OLD NORTH BRIDGE

TOWN OF CONCORD

June 23, 2014

Subject: Historic Interpretation along the Bruce Freeman Rail Trail – Phase 2B and 2C

Figure 4 (a). Plan view of Rest Area at Nashoba Brook

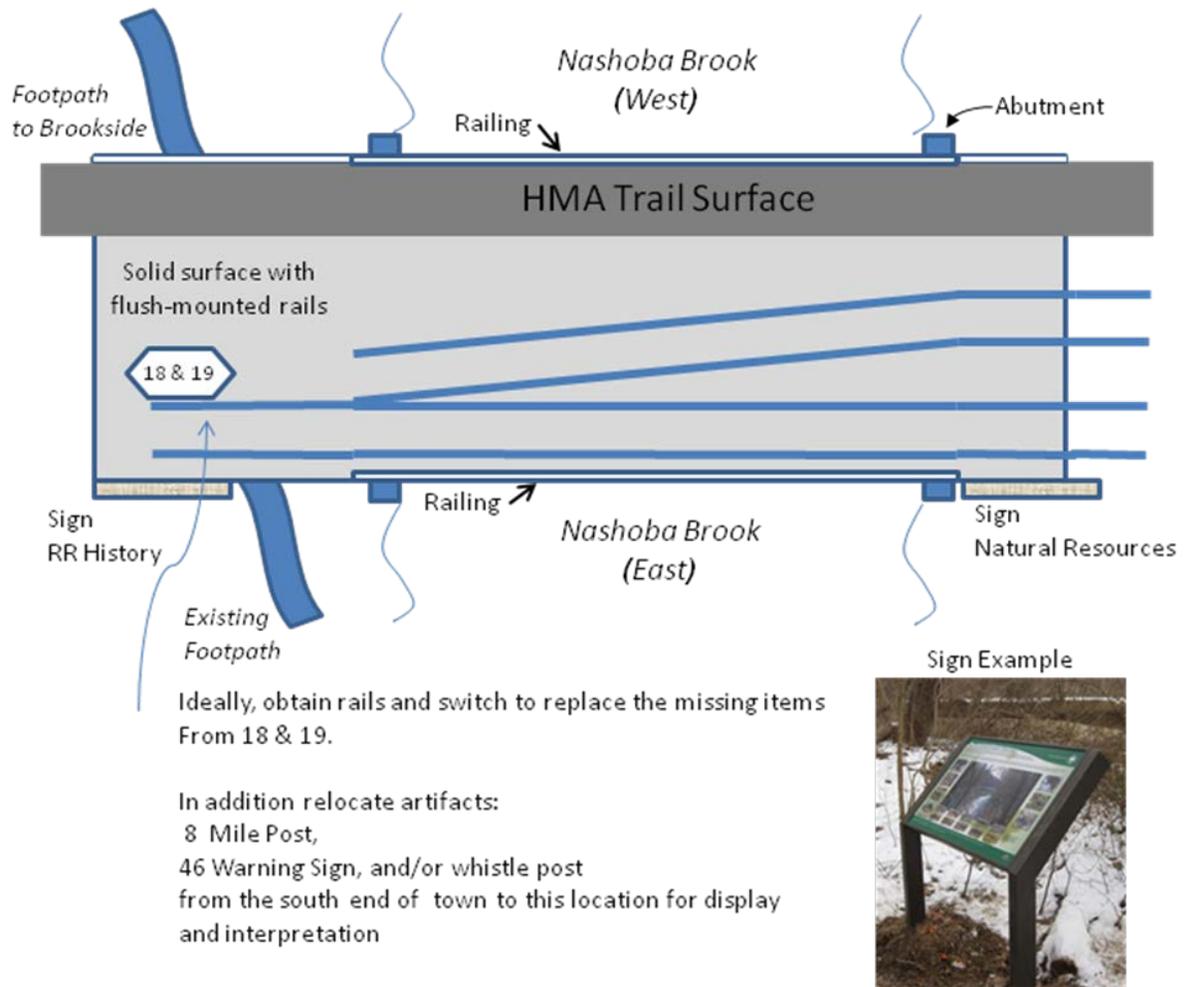
- Phase 2C – Bridge 14.81 Nashoba Brook Rest Area: The bridge rest area will be a focal point for historic interpretation of the railroad artifacts. We envision that the rest area will include the bridge viewing area and also extend past the bridge structure for several feet in both the north and south direction. The Town would like to retain the full width of bridge 14.81. The trail travel surface would occupy the west end of the bridge width and a rest area would occupy the east 2/3 of the width of the bridge. Figure 4 (a) shows a plan view of the bridge and rest area. Figure 4 (b) shows a cross-section through the bridge.

The 25% design created by VHB shows a safety railing between the trail surface and the rest area; however, the Town would prefer to eliminate the safety railing and have a continuous, level surface between the hot-mix asphalt travel surface and the rest area surface. In addition, the Town requests that GPI propose locations for two benches within the rest area. When preparing the design of this bridge, rest area, and signage, GPI should be mindful of the existing trail networks, driveways and new mixed use development near this bridge crossing. The signage at the bridge and display area should be of Type 1.

Figure 4 (b). Cross Section of Rest Area, Images of Highline Surface

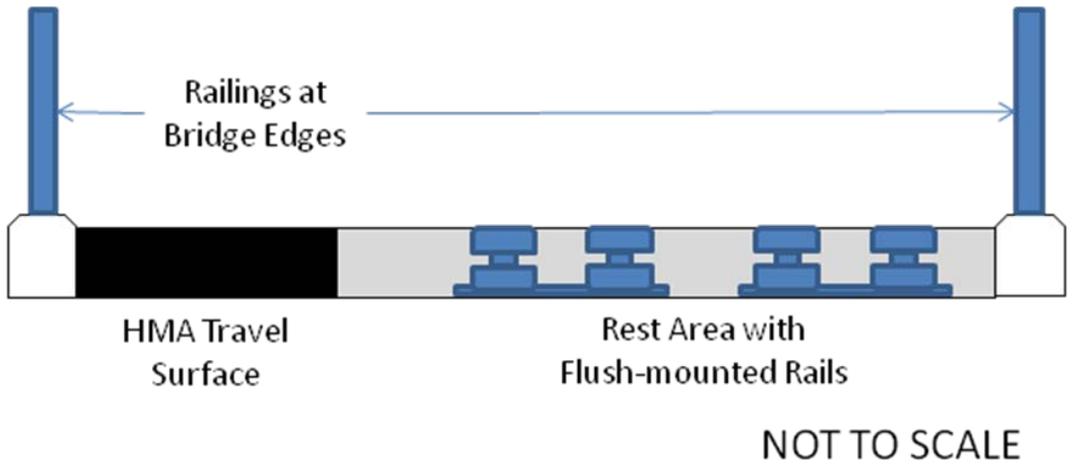
Currently, there is a new housing development (an assisted living project is being considered) proposed for the former prison land at the end of Winthrop St.; therefore, we would like to have the bridge rest area surface be a solid surface that can be flush-mounted with the rails. Figure 4 (b) contains photos of an installation in Manhattan (the High Line). However, another possibility could be porous pavers similar to that in Junction Park. We are looking for guidance from design consultant Greenman-Pedersen, Inc. (GPI) to propose a surface for the rest area. The Town would like a surface that has the following features:

- (a) is visually distinct from the hot-mix asphalt travel surface of the rail trail;
- (b) does not require a raised curb between the asphalt and rest area;
- (c) will not have sand, pebbles or other small granular material spilling onto the travel surface;
- (d) will work well with the new bridge drainage system and won't degrade the bridge structure;
- (e) will fit in with the aesthetics of West Concord Village.
